**PLANNING COMMISSION MEETING**  
**LOCATION: TOWNSHIP ANNEX, 7527 HIGHLAND ROAD, WHITE LAKE, MI 48383**  
**THURSDAY, JUNE 04, 2026 – 6:30 PM**

Project Name: Mack Industries  
 Description: Preliminary and final site plan approval  
 Date on Agenda this packet pertains to: June 4<sup>th</sup>, 2026

**RE: Mack Industries Addition - Preliminary Site Plan Review- 2<sup>nd</sup> Review  
-Final Site Plan Review-1<sup>st</sup> Review**

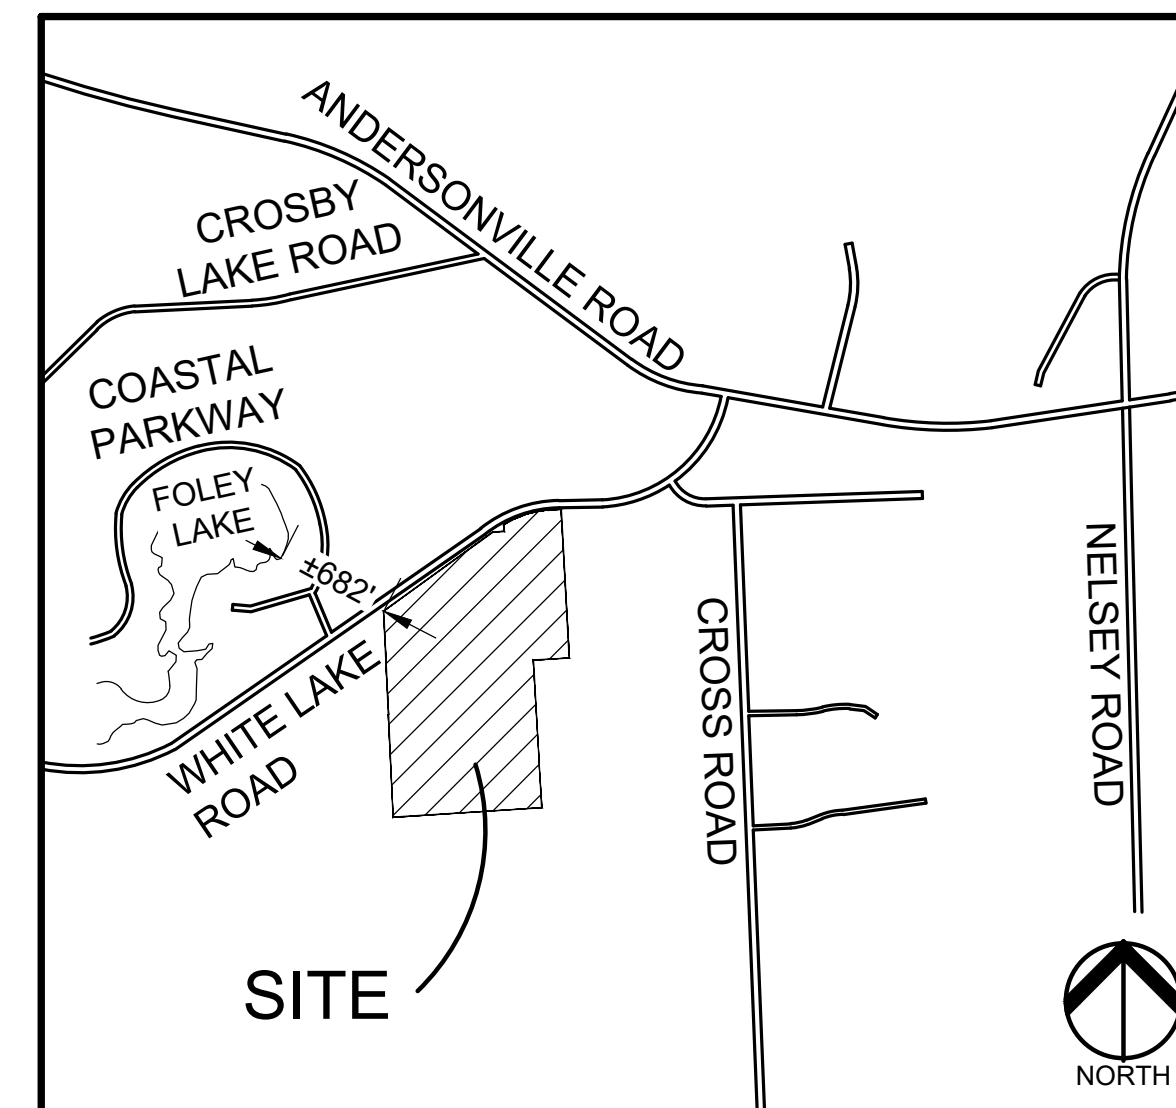
1. Cover Sheet C-0.0- Project Narrative- Paragraph 1- Building square footage has changed to 134,708. Please update.

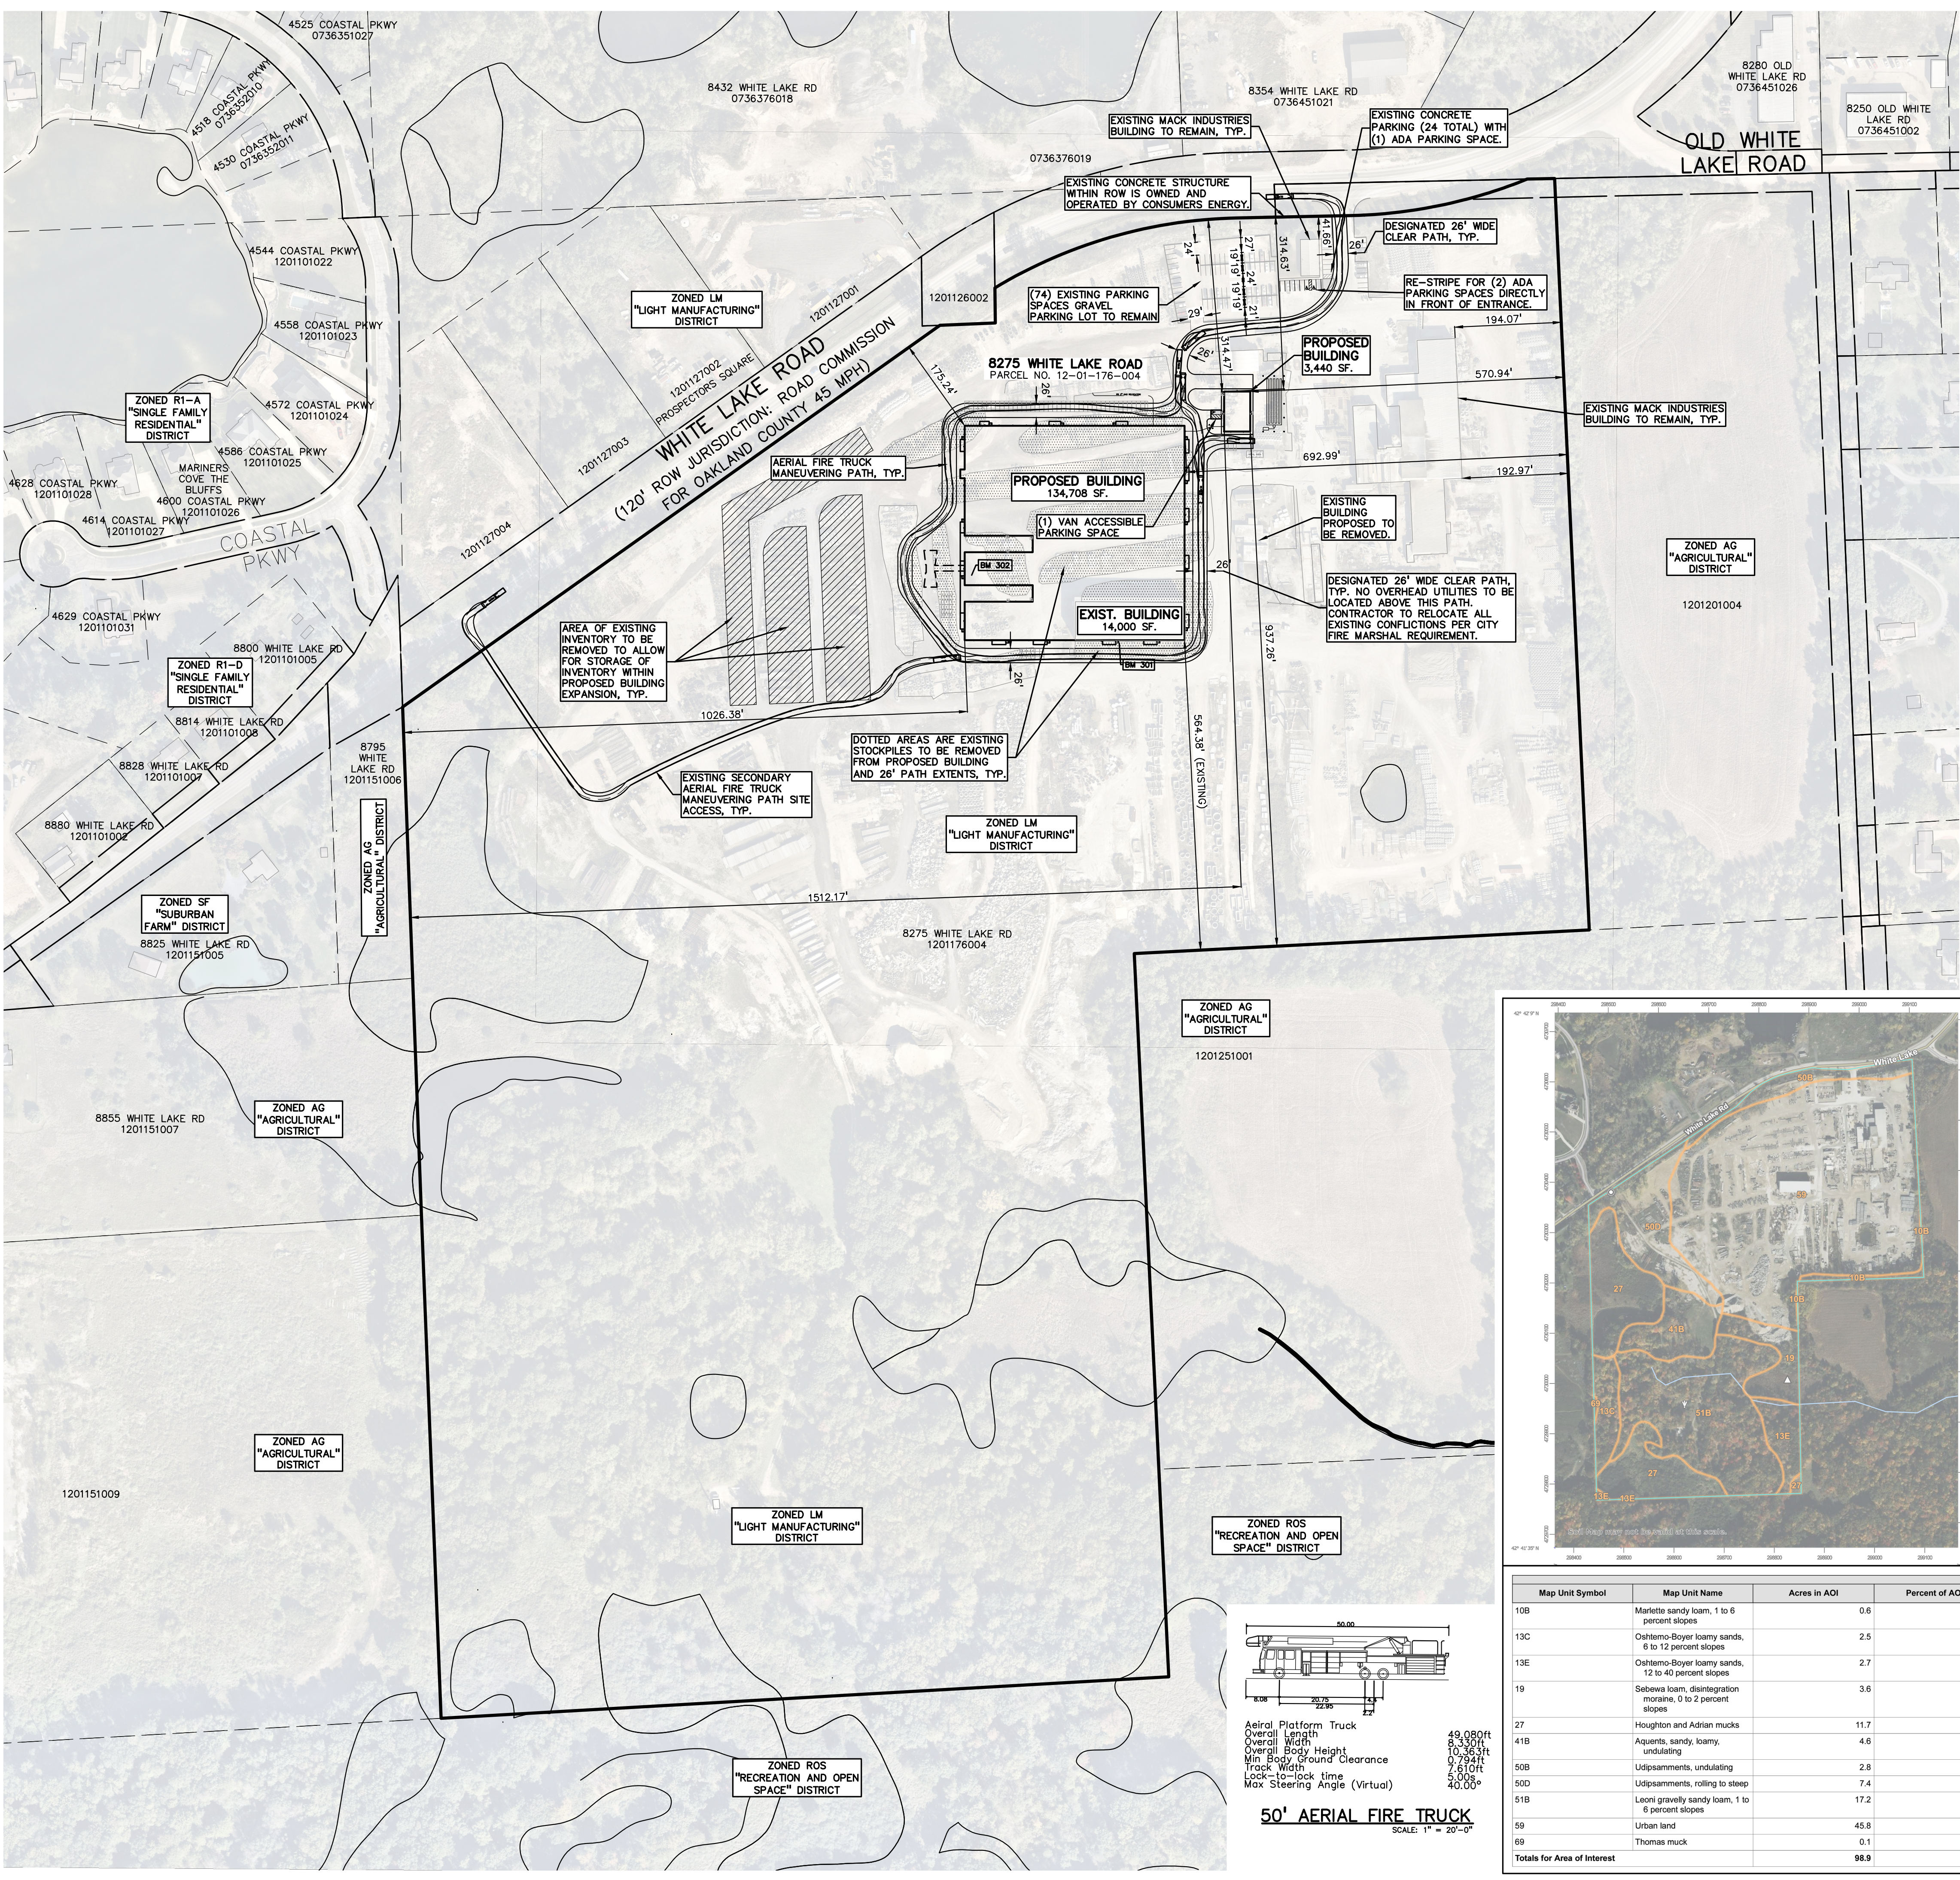
- We note that when using the scale provided on Sheet C-3.0 that the scale does not correspond to the plan dimensions proposed. Please revise.

**NOTES AND DETAILS**

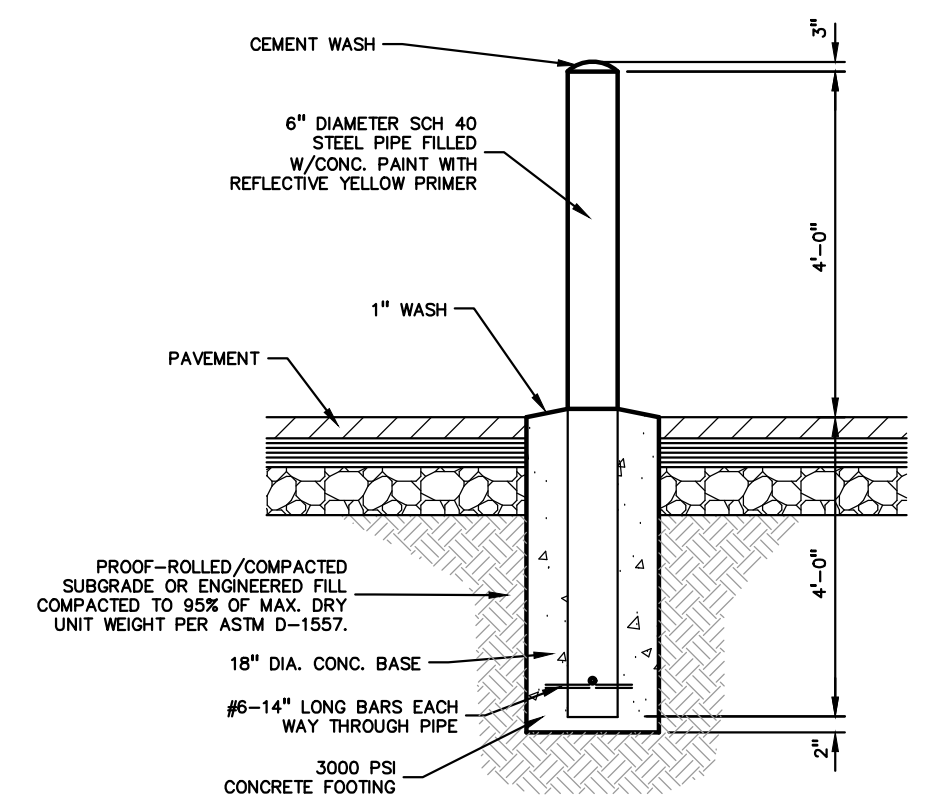
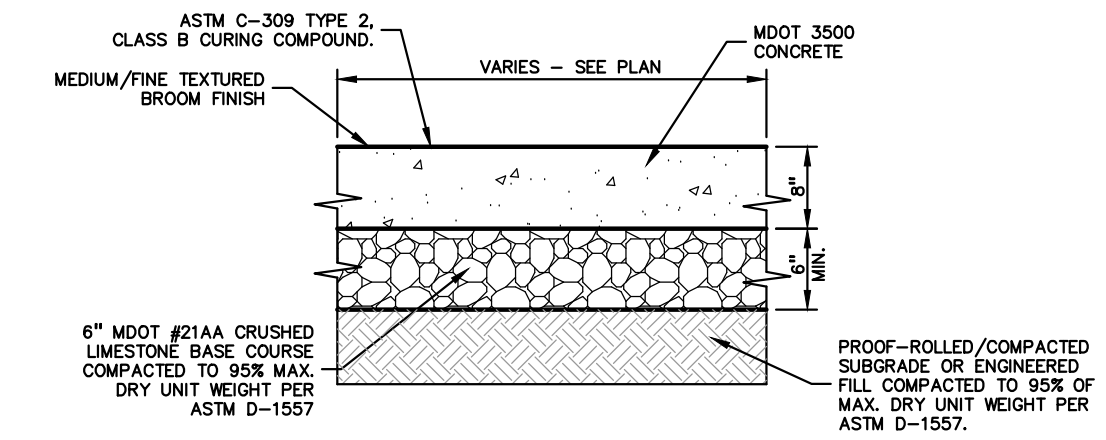
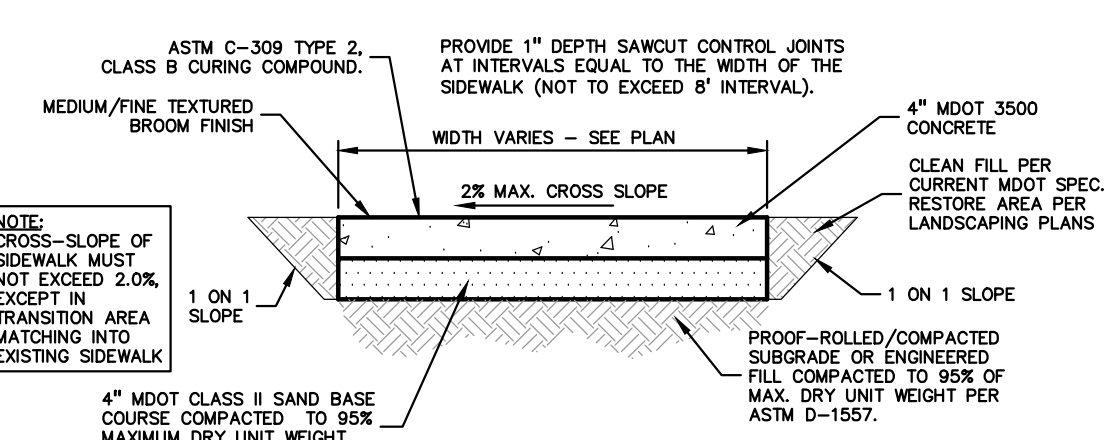
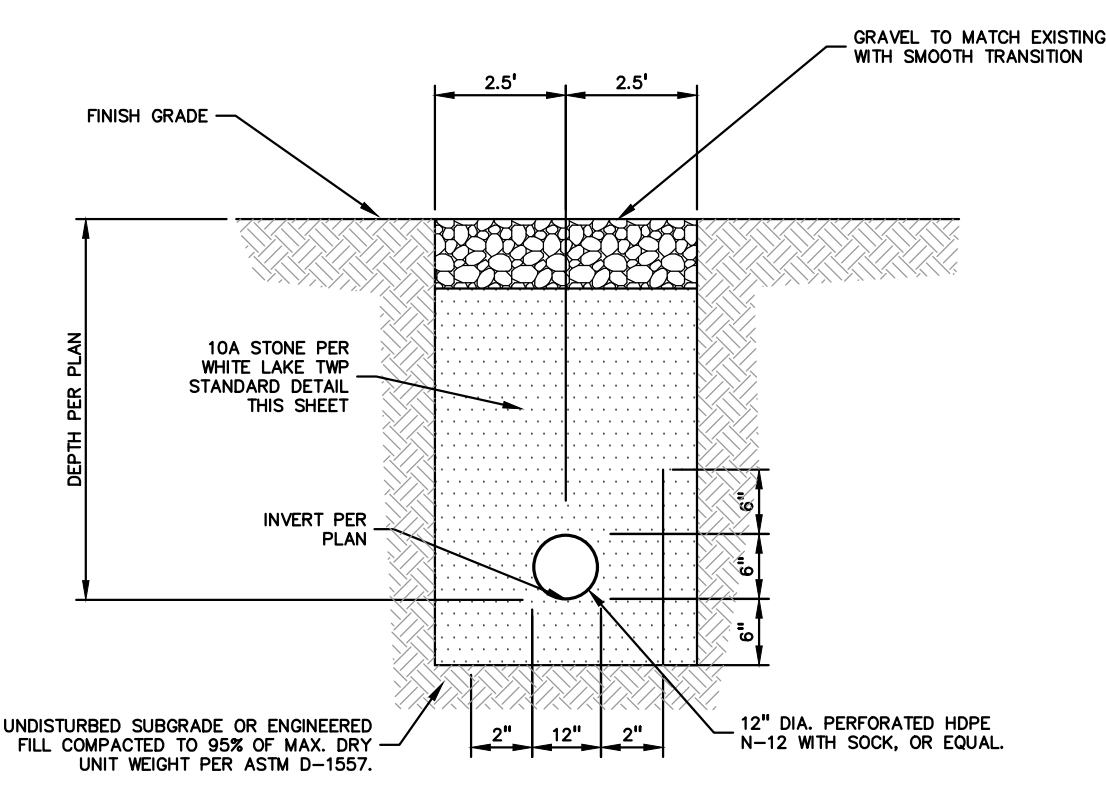
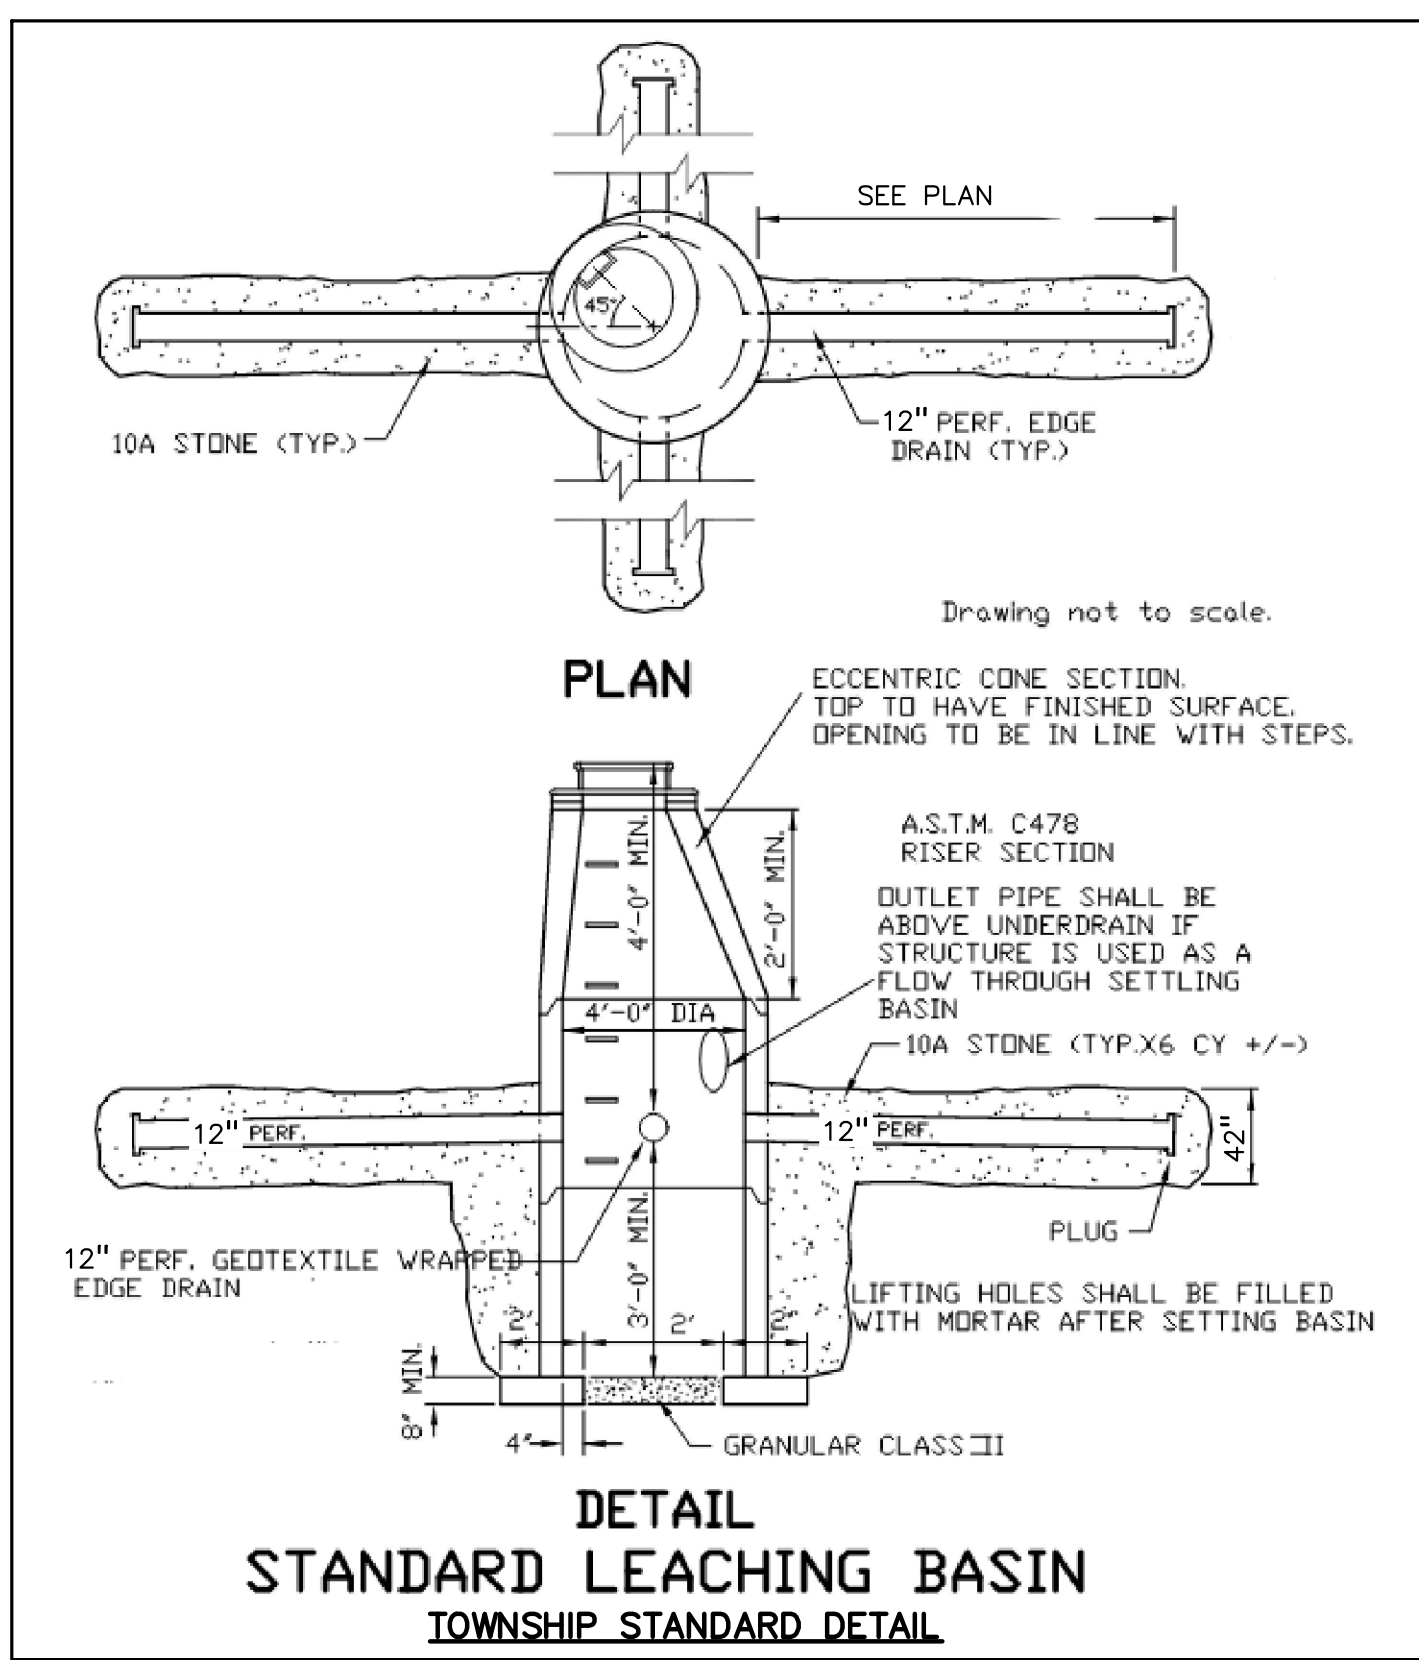
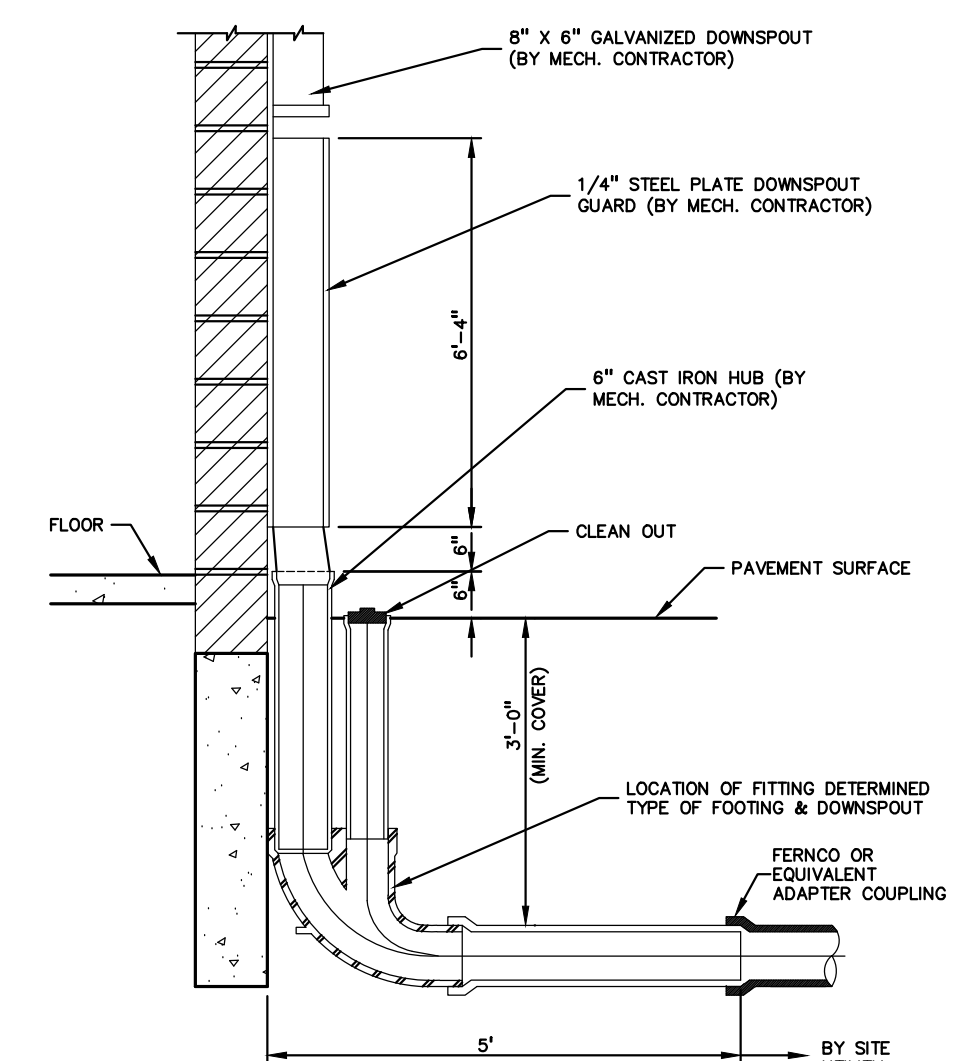
- Sheet C-9.0- Remove duplicate concrete sidewalk detail on this sheet.* **Comment addressed. Duplicate detail has been removed.**

3. *The leaching basin detail shown on Sheet C-9.0 shall be per Township Storm Sewer Details or subject to DLZ's review and approval. See Comment 1c above. **Comment addressed. The detail is per Township standard detail and has now been labeled as such.***
